**Re: Response to NYSDEC comments #8 and #23 on RI/IRM/AA Report
Additional Groundwater Sampling Work Plan
Moog 170 Jamison Road Site, Elma, NY (Site)
NYSDEC Site No. 915315**

170 JAMISON ROAD SITE
BCP SITE NO. C918315
ELMA, NEW YORK
PREPARED FOR
MOOG INC.

FIGURE 1

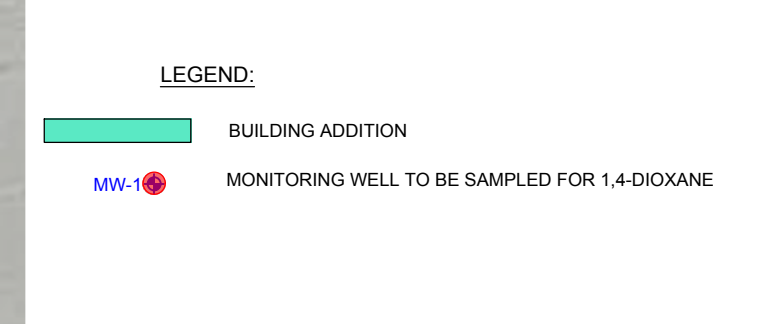
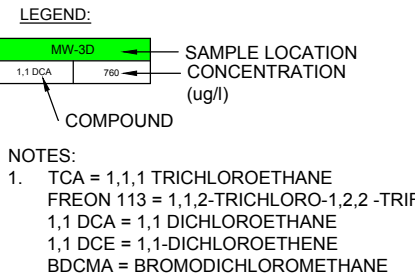
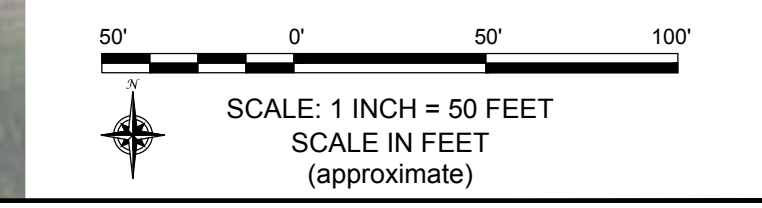
Regarding Comment #8, the NYSDEC has indicated the complete extent of 1,4-dioxane contamination remains undetermined, and additional sampling of all site related monitoring wells for 1,4-dioxane is required. The NYSDEC has requested that additional groundwater sampling for 1,4-dioxane conform with the emerging contaminant sampling guidance previously provided by the Department.

Moog will collect groundwater samples for 1,4-dioxane analysis from seventeen monitoring wells (MWs) as follows: MW-6, MW-7, MW-7D, , MW-8, MW-9, MW-9D, MW-11, MW-11D, MW-12, MW-13, MW-13D, MW-20, MW-20D, MW-21, MW-22, MW-22D, MW-23 and MW-23D (Refer to Figure 1 attached).
